To: T10 Technical Committee
From: Rob Elliott, HP (elliott@hp.com)
Date: 6 September 2004
Subject: 04-167r1 SAS-1.1 Invalid dword handling

Figure 1 — Receive data path in a SAS phy

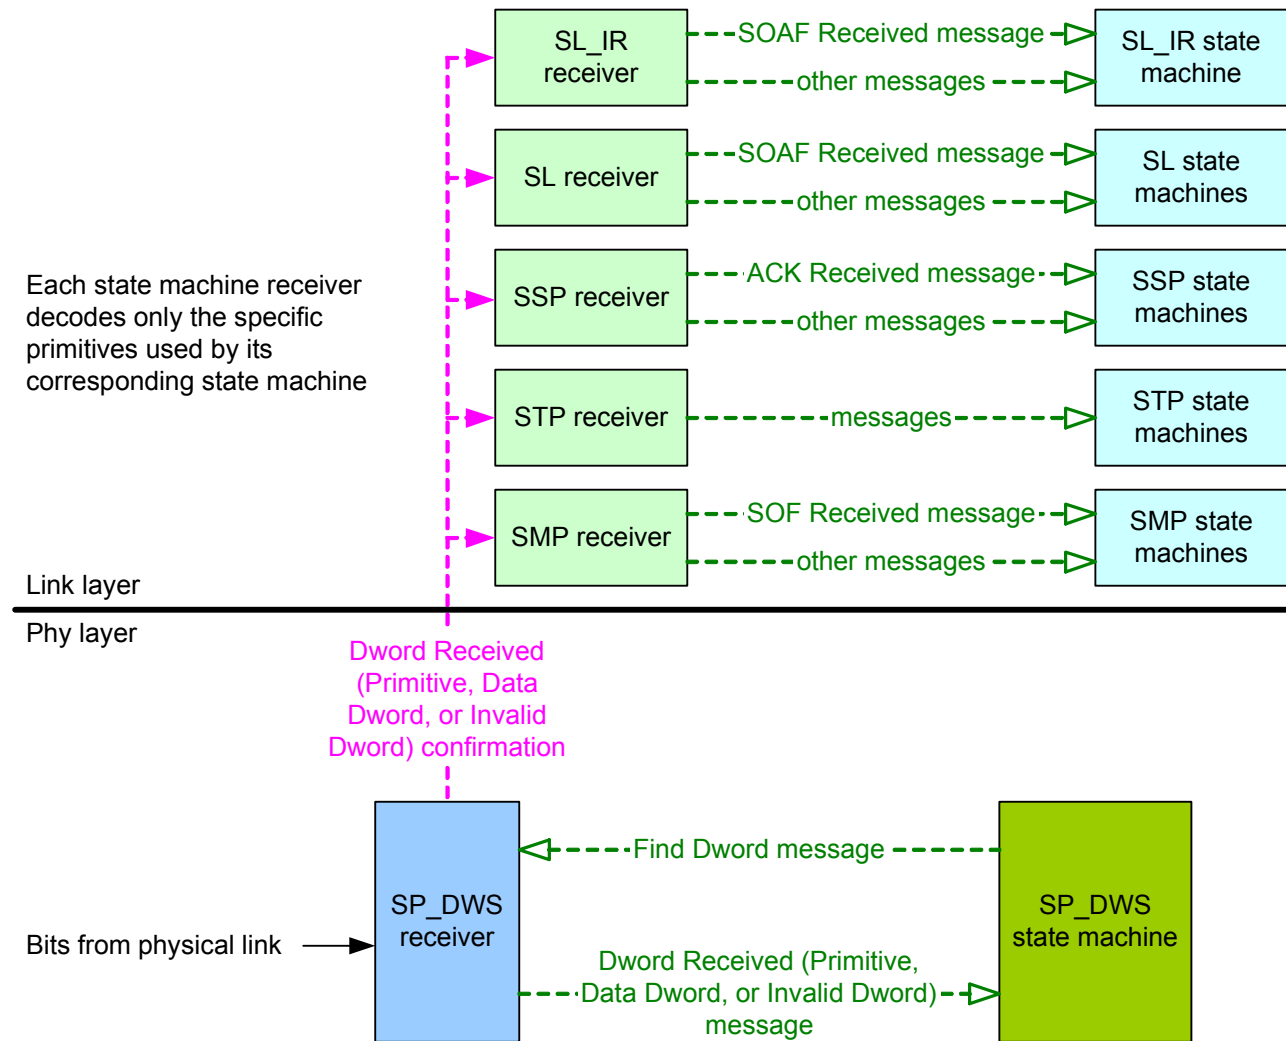
[4.3.n Receive data path](#)

[The SP_DWS receiver establishes dword synchronization and sends dwords to the SP_DWS state machine and to the link layer state machine receivers.](#)

Figure 1 shows the receive data path in a SAS phy.

Figure 2 — Receive data path in an expander phy

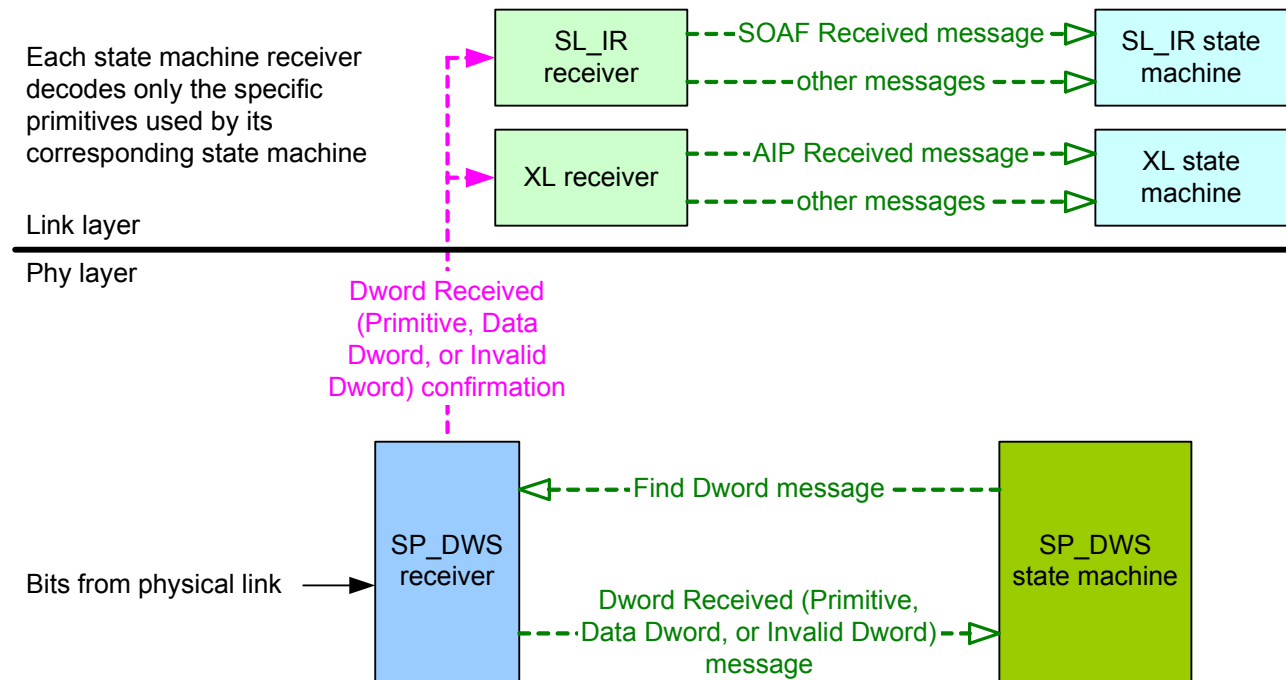
Figure 2 shows the receive data path in an expander phy.
